| Well Name: CORRAL 22-34 FED COM | Well Location: T25S / R29E / SEC 22 / NWNE / 32.121124 / -103.969428 | County or Parish/State: EDDY / NM |
| Well Number: 302H | Type of Well: CONVENTIONAL GAS WELL | Allottee or Tribe Name: |

Type of Submission: Notice of Intent Type of Action: APD Change

Procedure Description: XTO Energy Inc. respectfully requests approval to make the following changes to the approved APD. Changes include KOP, FTP, LTP, BHL, Proposed total depth, Formation TVD, Casing Design, Cementing Program, Mud Program. APD ID 10400098689; Well API: 30-015-56566 FROM: TO: KOP: 596' FNL & 1765' FEL OF SECTION 22-T25S-R29E 617' FSL & 2151' FEL OF SECTION 15-T25S-R29E FTP: 100' FNL & 2430' FEL OF SECTION 22-T25S-R29E 100' FNL & 2150' FEL OF SECTION 22-T25S-R29E LTP : 330' FSL & 2430' FEL OF SECTION 34-T25S-R29E 330' FSL & 2150' FEL OF SECTION 34-T25S-R29E BHL: 50' FSL & 2430' FEL OF SECTION 34-T25S-R29E 280' FSL & 2150' FEL OF SECTION 34-T25S-R29E The proposed total depth is changing from 26922' MD; 10474' TVD to 27276' MD; 11139' TVD. There is no new surface disturbance. See attached drilling program for Primary & Contingency design with Updated formation, casing design, ce

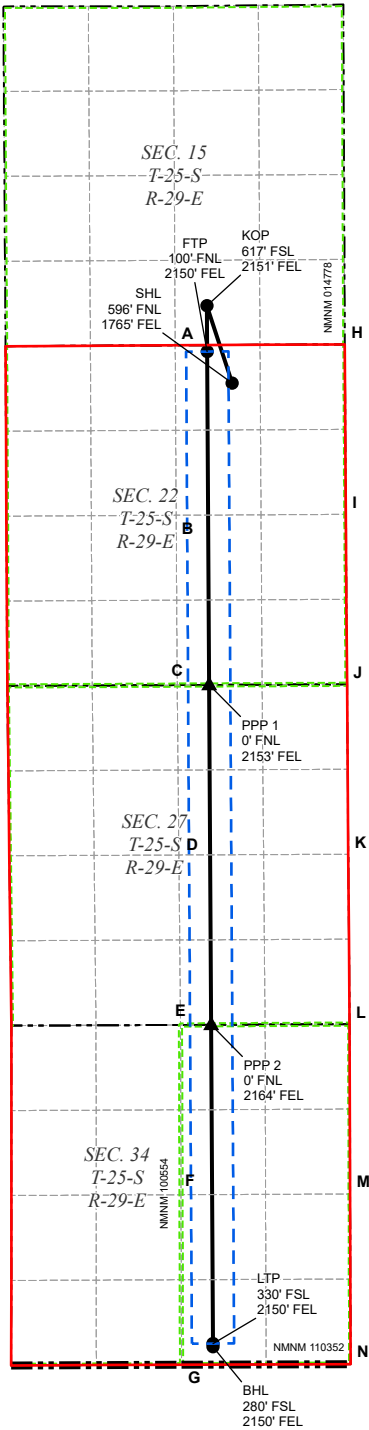
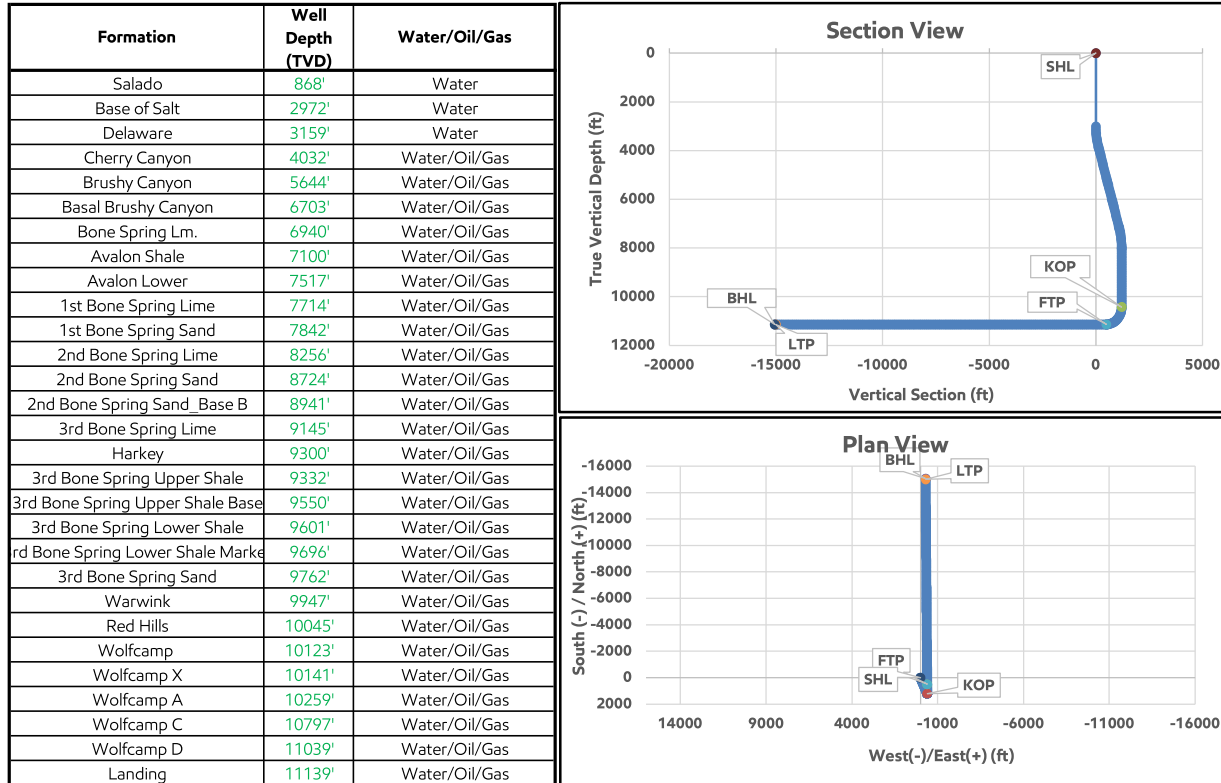
KOP: 596' FNL & 1765' FEL OF SECTION 22-T25S-R29E 617' FSL & 2151' FEL OF SECTION 15-T25S-R29E
FTP: 100' FNL & 2430' FEL OF SECTION 22-T25S-R29E 100' FNL & 2150' FEL OF SECTION 22-T25S-R29E
LTP : 330' FSL & 2430' FEL OF SECTION 34-T25S-R29E 330' FSL & 2150' FEL OF SECTION 34-T25S-R29E
BHL: 50' FSL & 2430' FEL OF SECTION 34-T25S-R29E 280' FSL & 2150' FEL OF SECTION 34-T25S-R29E

The proposed total depth is changing from 26922 MD; 10474 TVD to 27276 MD; 11139 TVD.
